GOULDEN STREET, MANCHESTER

REPORT TO DISCHARGE DRAINAGE
RELATED PLANNING CONDITION

Report Title: Report to Discharge Proposed Drainage Related Planning Condition

Report Reference: 5015327-RDG-00-ZZ-RP-C-0001

TITLE:
DRAINAGE GA

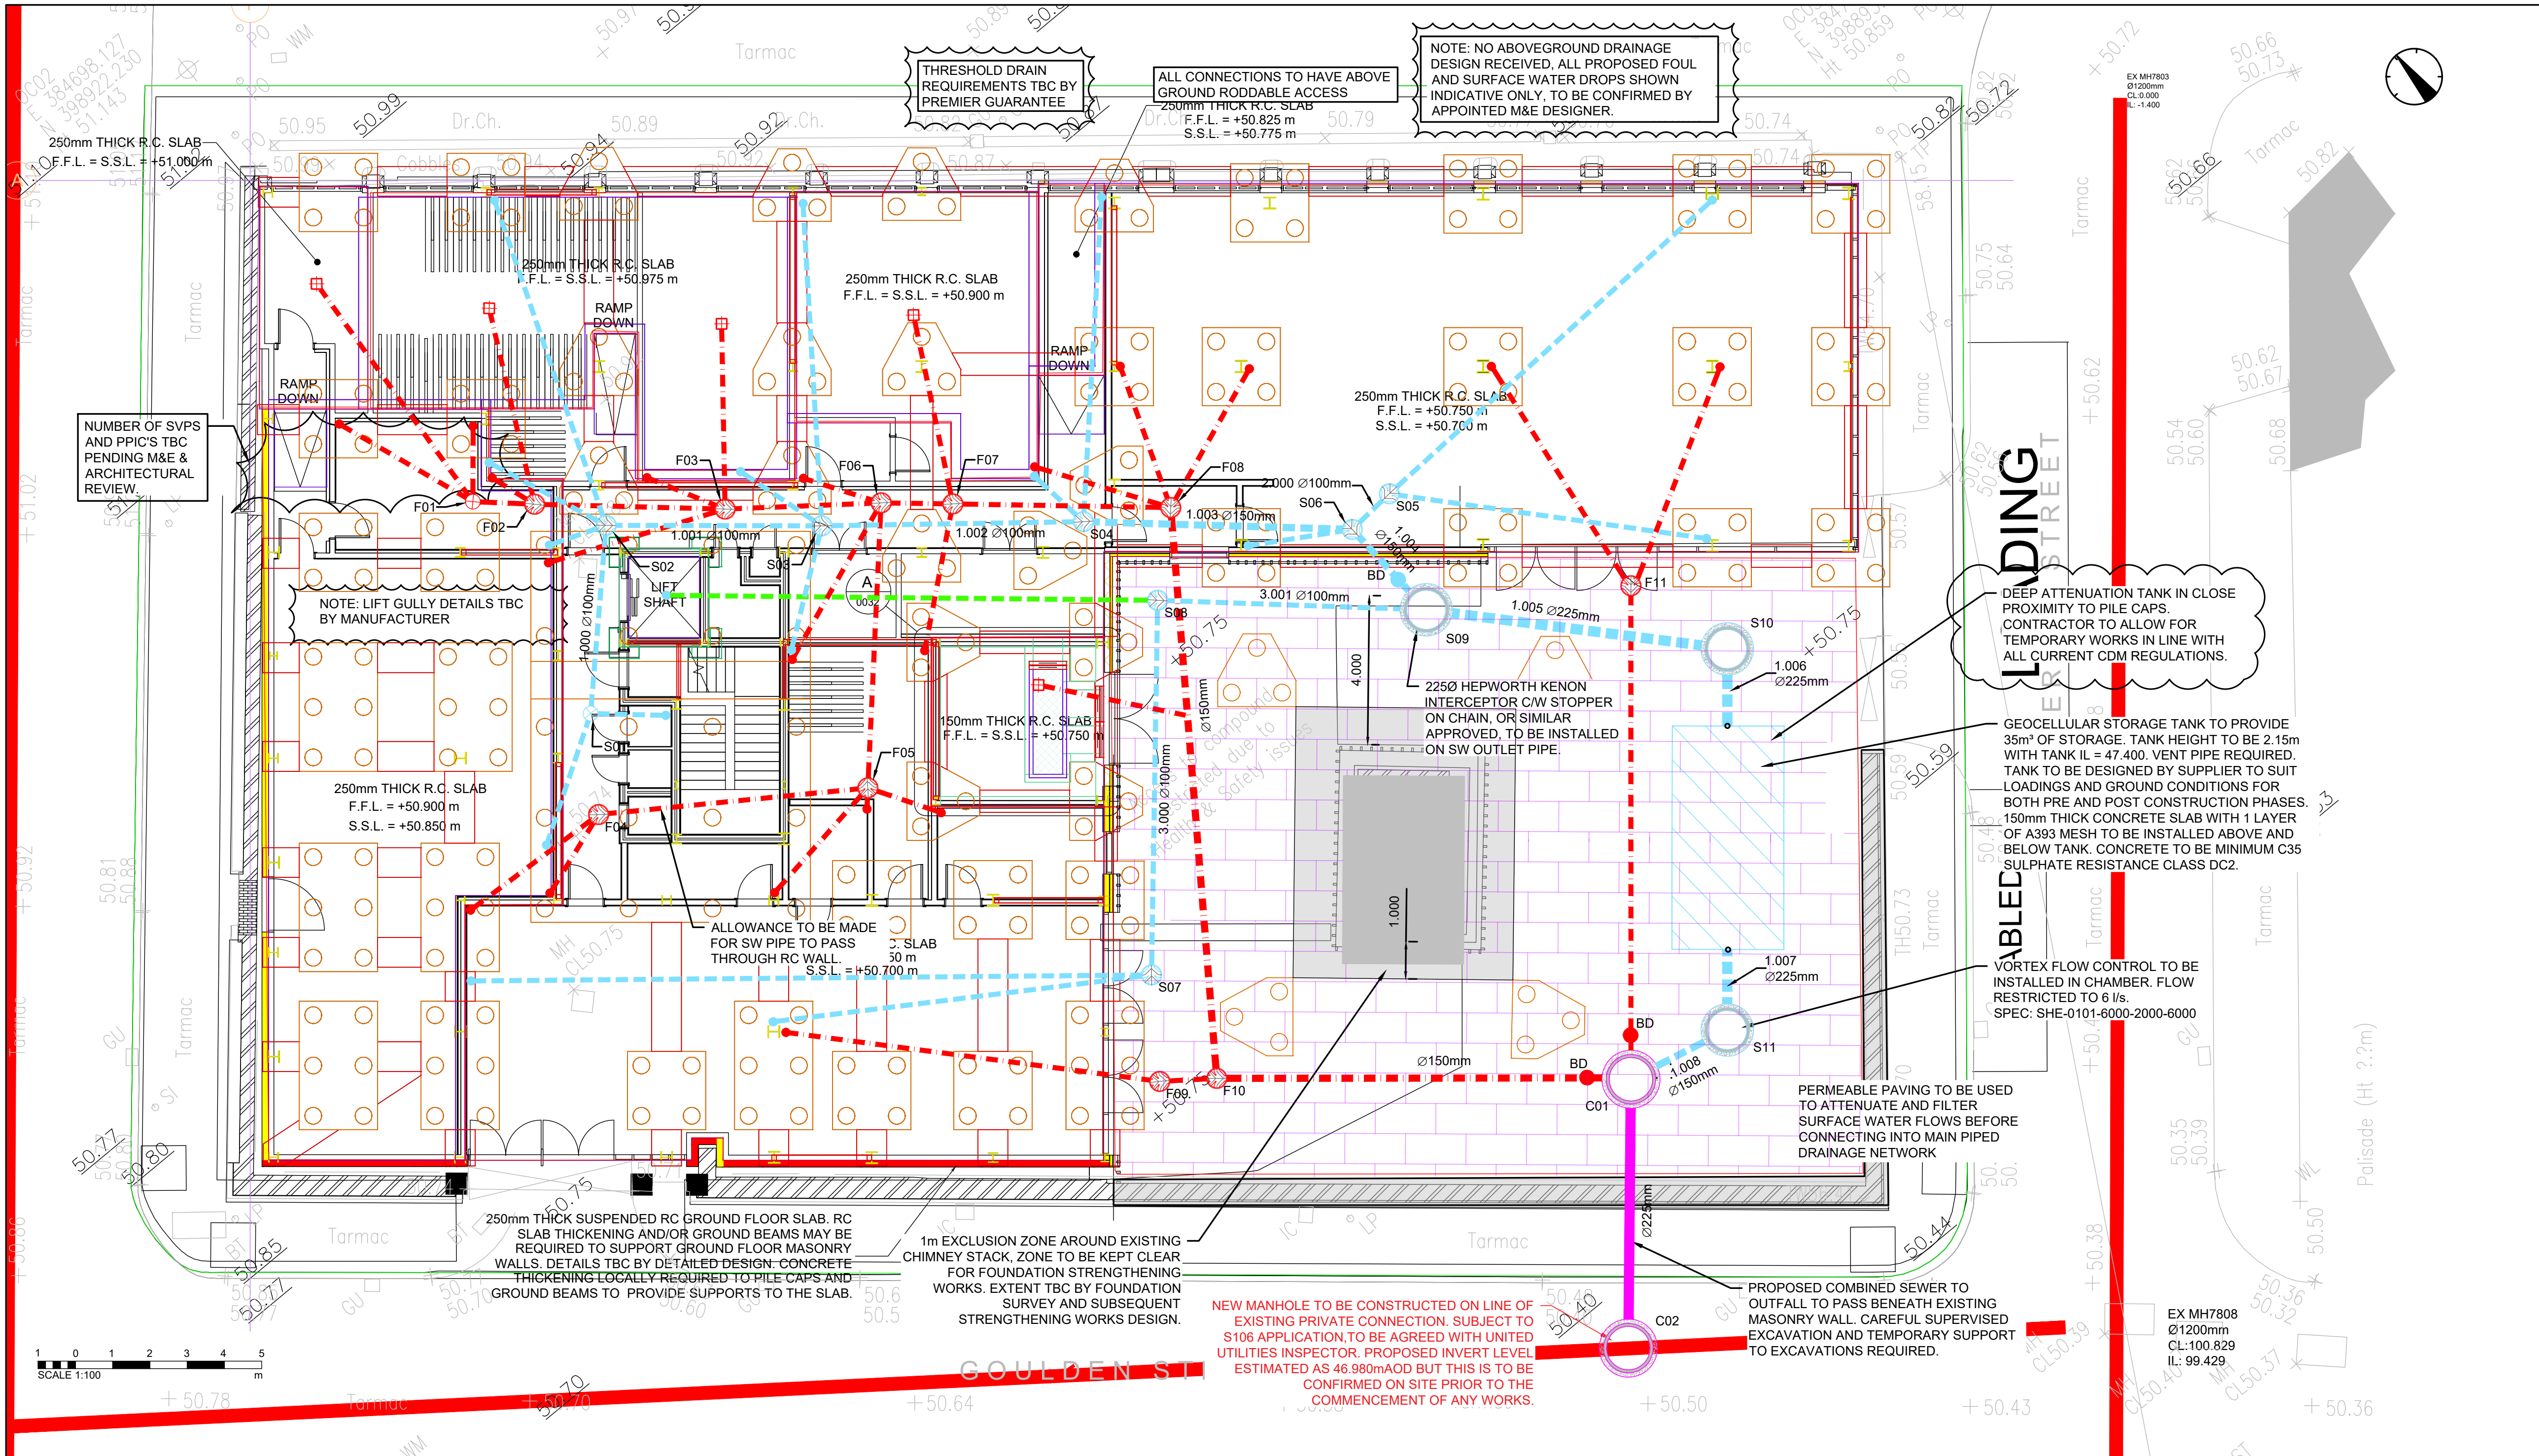
The surface water drainage layout must be amended to clearly demonstrate the point of outfall onto United Utilities sewer and include an invert level.

SuDS features should be appropriately positioned away from proposed buildings. The developer will need to confirm the current attenuation tank easements from proposed dwellings and existing highway infrastructure. Good practice is typically 2.5m easement from existing boundaries, 5m from any dwellings, to enable future maintenance access.

In the instance this location is the only available option, and good practice cannot be achieved. The developer will need to provide a plan demonstrating proposed easements from buildings / structures and boundaries. The developer must also provide a site-specific cross-section through the attenuation tank including foundation details. This should include permeable paving to review how the components interlink.

The surface water drainage layout must be amended to clearly demonstrate the point of outfall onto United Utilities sewer and include an invert level. No invert level has been provided. The developer will need to amend the submitted drawing to reflect existing invert level.

The updated proposed drainage GA drawing 5015327-RDG-00-XX-DR-C-0101, which shows the UU sewers within the highways is attached in Appendix A.

The proposed attenuation tank has been relocated to ensure it is further away from the proposed building. An additional chamber has also been added upstream of the tank to allow for easier access for maintenance of the tank. The Proposed Drainage GA drawing 5015327-RDG-00-XX-DR-C-0101 and all other relevant drawings have been updated to reflect this change and the updated drawings are all attached in Appendix A.

The updated drawings attached in Appendix A indicate the invert level of the outfall manhole C02. However, it should be noted that the invert level is to be confirmed on site prior to the commencement of any works.

VORTEX CONTROL CHAMBER

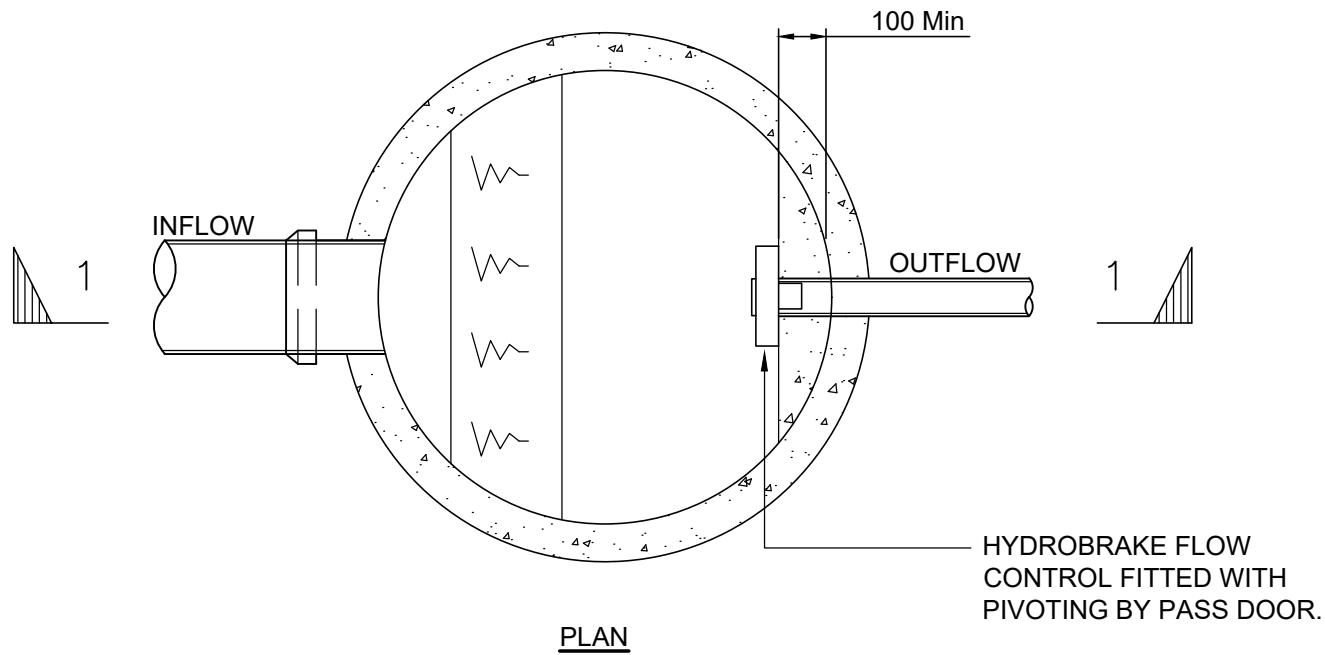
Construction details of flow control and SuDS elements. – Hydro-brake construction details need to be submitted (Spec: SHE-0101-6000-2000-600).

Construction details of flow control and SuDS elements. – Hydro-brake construction details need to be submitted (Spec: SHE-0101-6000-2000-600).

The 'vortex control chamber' detail includes a 150mm overflow during the event of an emergency. To ensure discharge is always limited to the maximum rate (6l/s), can the developer please include

top water level for each return period within a specific section. Discharge rates must always be limited to a maximum of 6l/s.

A typical detail of the hydrobrake chamber is attached within the drainage details drawing 5015327-RDG-00-XX-DR-C-0102, located in Appendix A. The hydro international specific construction detail has also been added to Appendix A.

The hydrobrake construction details are indicated on Ridge drawing 5015327-RDG-00-XX-DR-C-0107, which is attached in Appendix A. As can be seen the water levels within the hydrobrake chamber for the; 1 year, 30 year and 100 year + 40% CC have all been included on the drawing. The water levels indicate that the high level overflow pipeline will only be utilised during events in exceedance of the 1 in 100 year +40% climate change event. Therefore, the surface water discharge rate will be restricted to a maximum discharge rate of 6.0 L/s for all rainfall events up to and including the 1 in 100 year +40% climate change event.

SECTION A
THROUGH ATTENUATION TANK

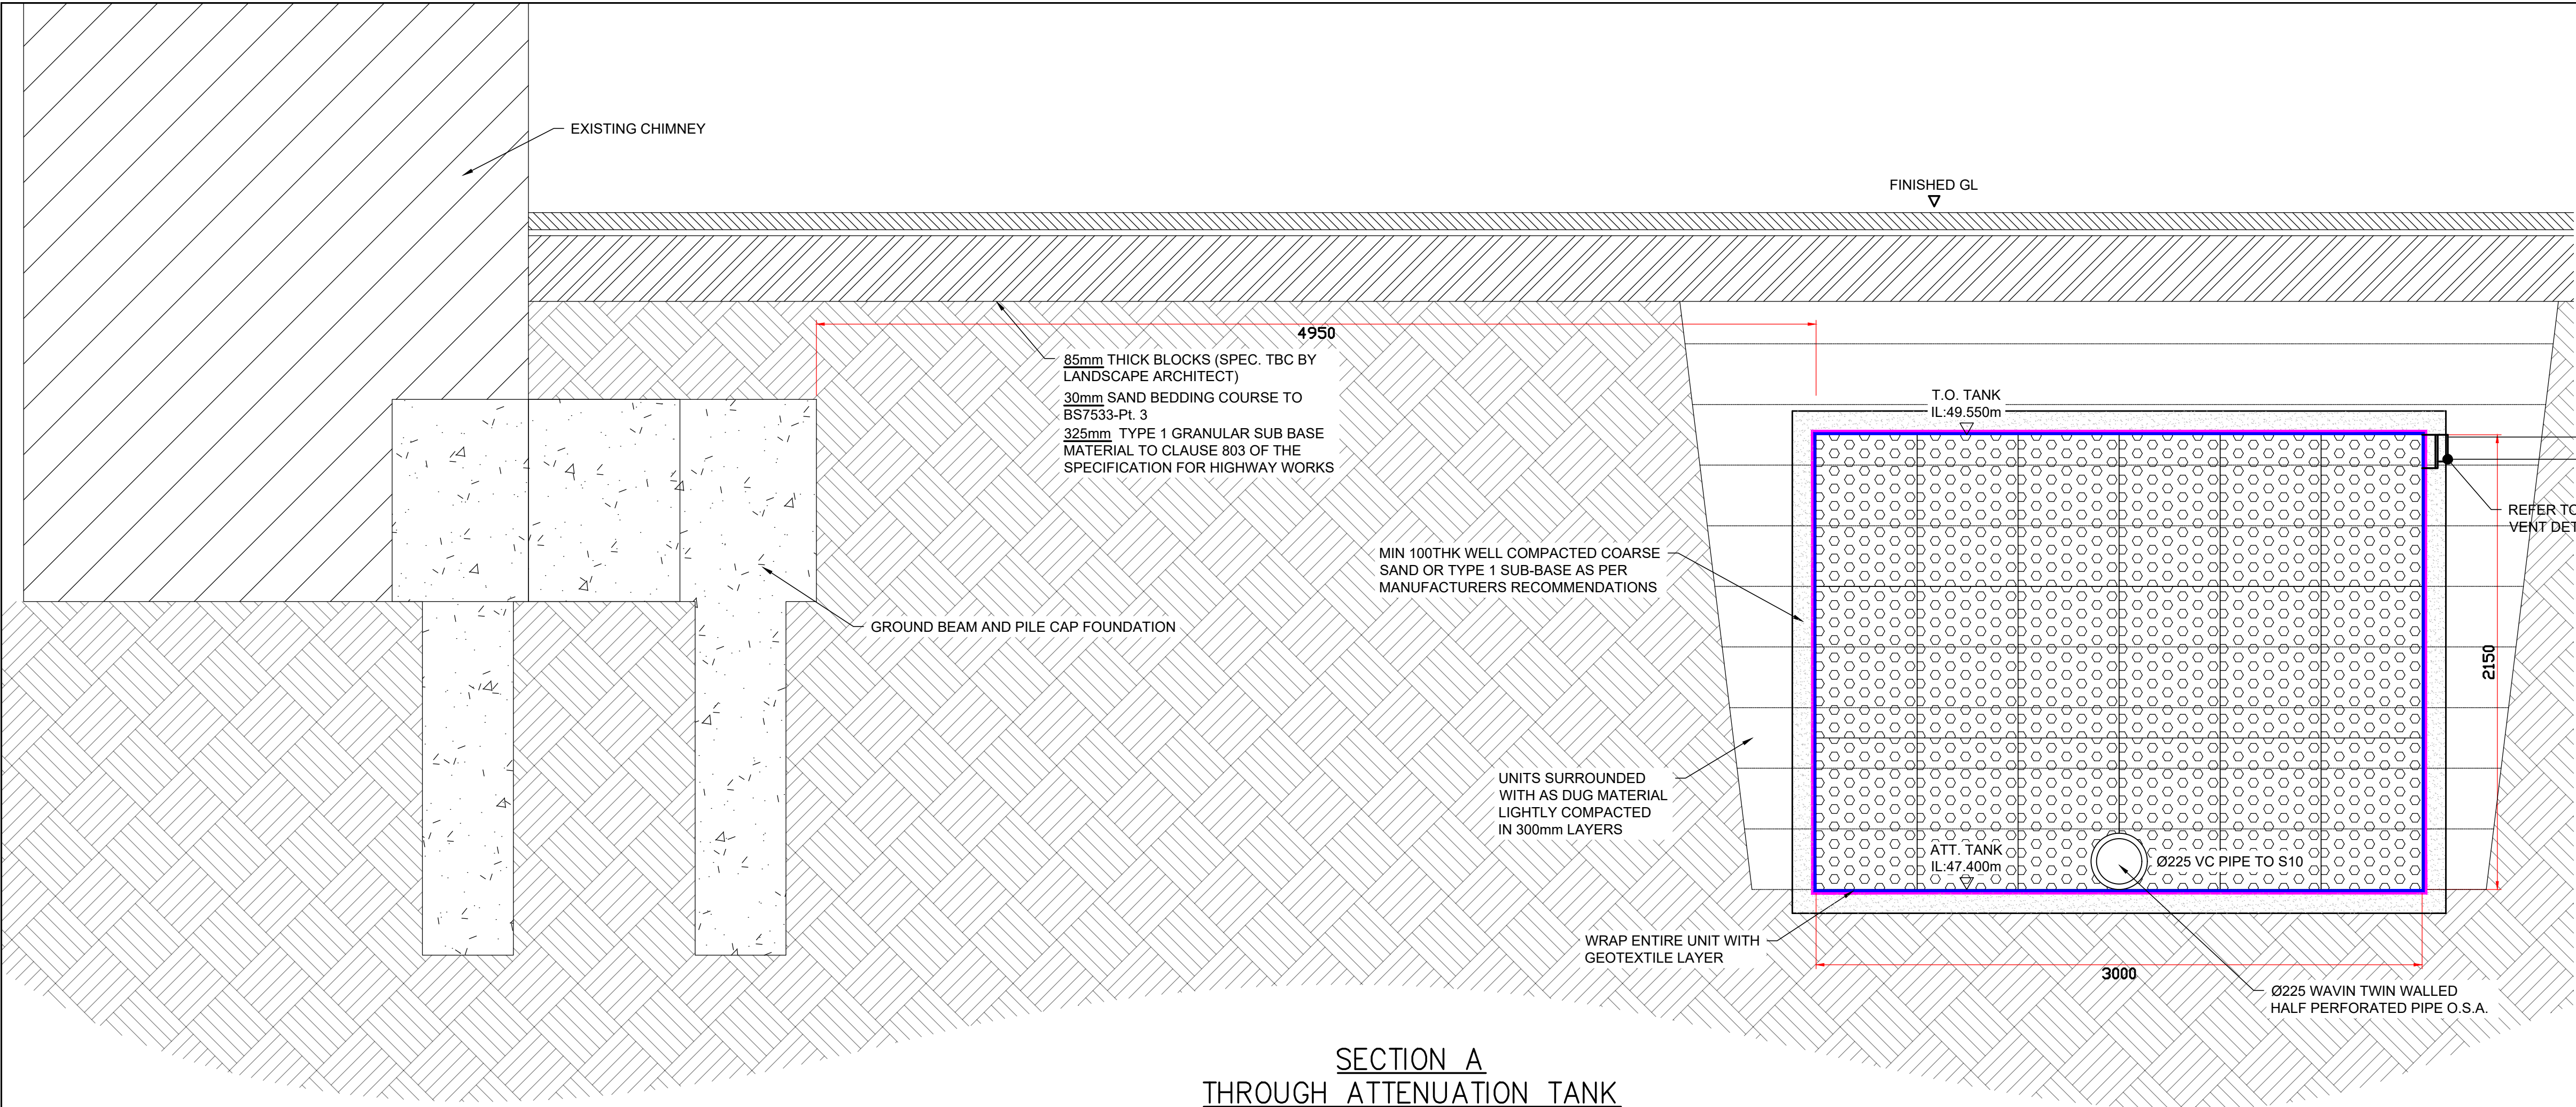
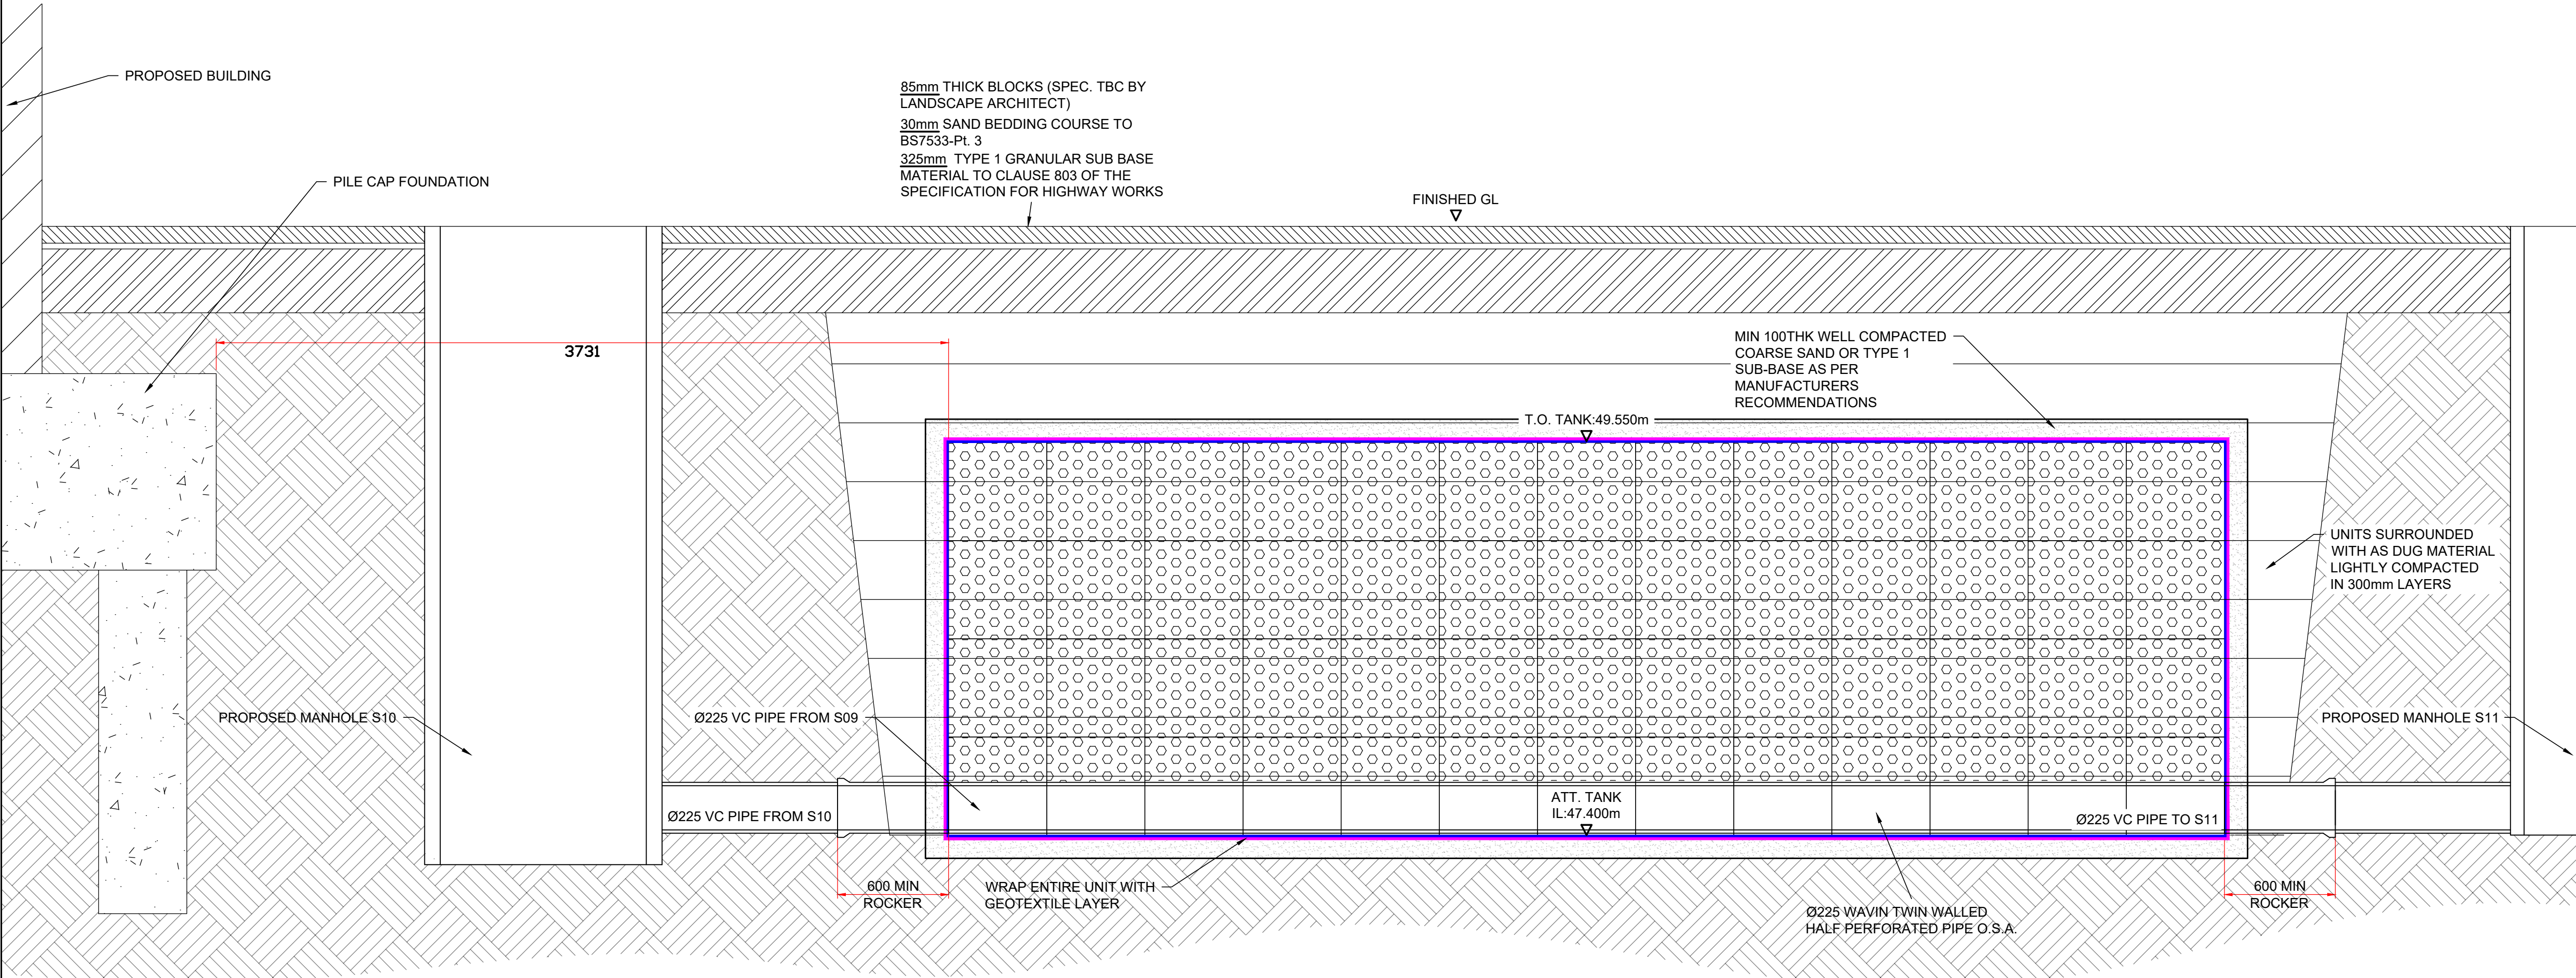
In the instance of tank failure, or full replacement. The appointed private maintenance company will need to be made aware of the potential future risk, when adopting this structure (attenuation tank).
